VEHICLE MANUFACTURER NOTICE LETTER

Subject: VAPOR BUS INTERNATIONAL VOLUNTARY SAFETY RECALL

Reference: National Highway Traffic Safety Administration ("NHTSA") Campaign ID: 15E033

Figure 1 - ETO Controller Assembly Labeling

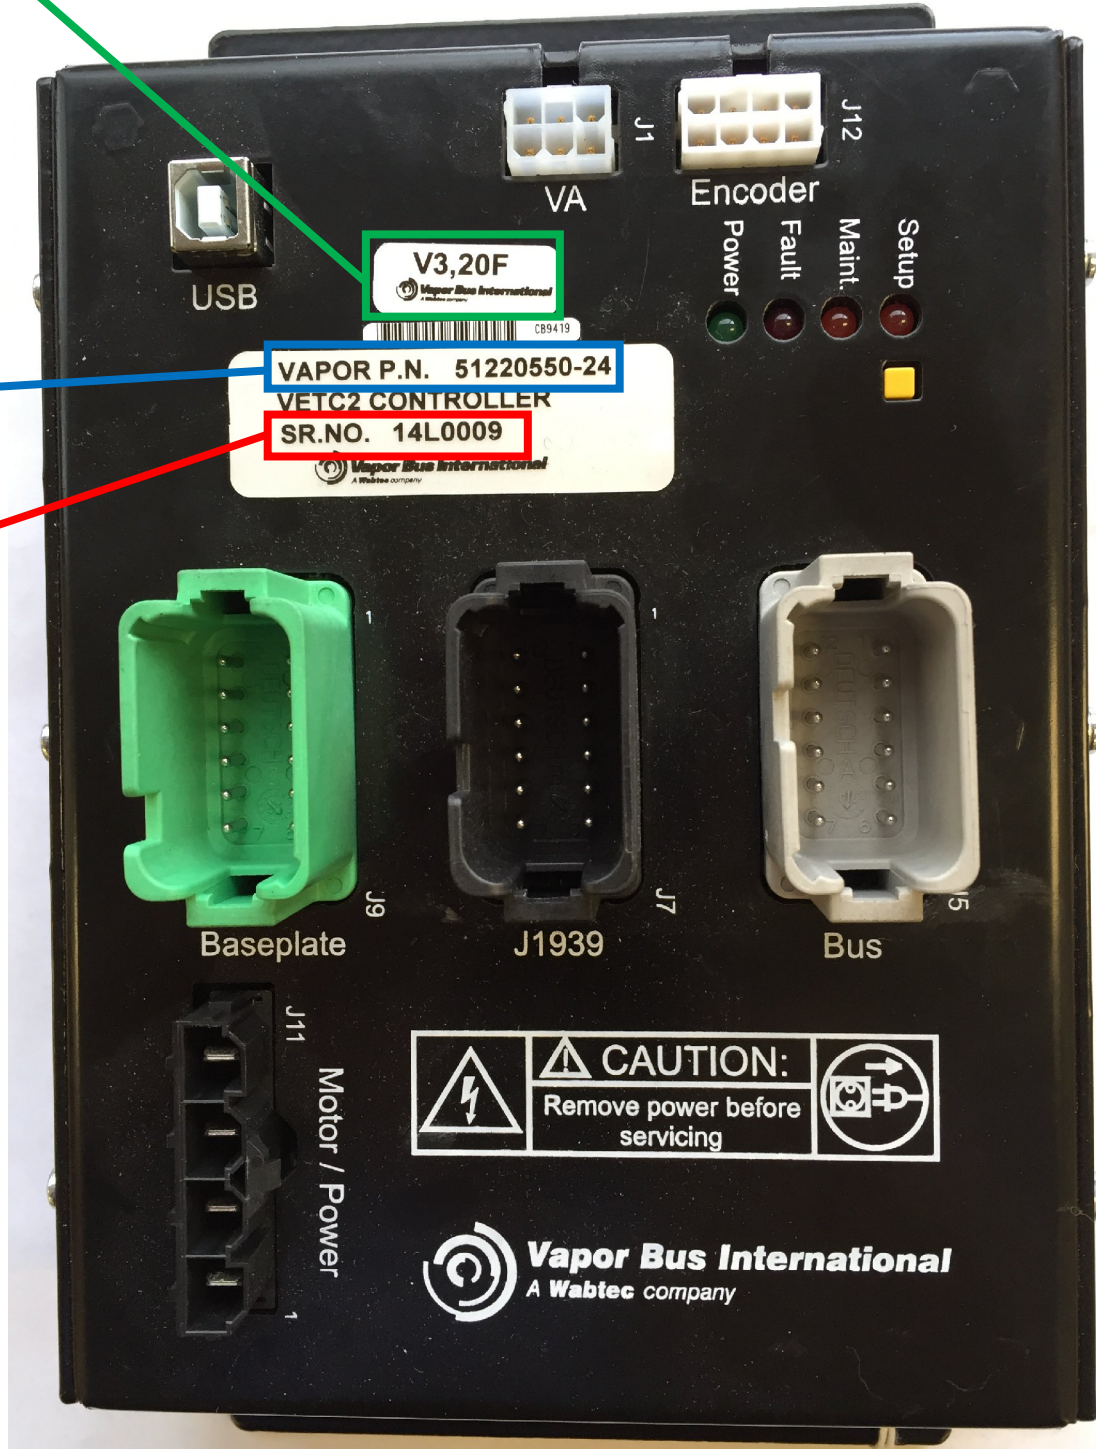
Vapor Bus International will work with the bus manufacturer to update the ETO Controller Assembly software on all affected units free of charge. The updated version of software will provide door closed status to the bus multiplex system as soon as it transitions from the “door closed pre-load” to “door recycle open” state. All ETO Controller Assemblies that receive the updated software will be identified with a label affixed to the ETO Controller enclosure that indicates the new software revision level (see Figure 1).

NEW
SOFTWARE
REVISION
LABEL
"V3.XXX"
WILL BE
APPLIED IN
THIS AREA
(NOTE:
SOFTWARE
VERSION IS
PART NUMBER
SPECIFIC)
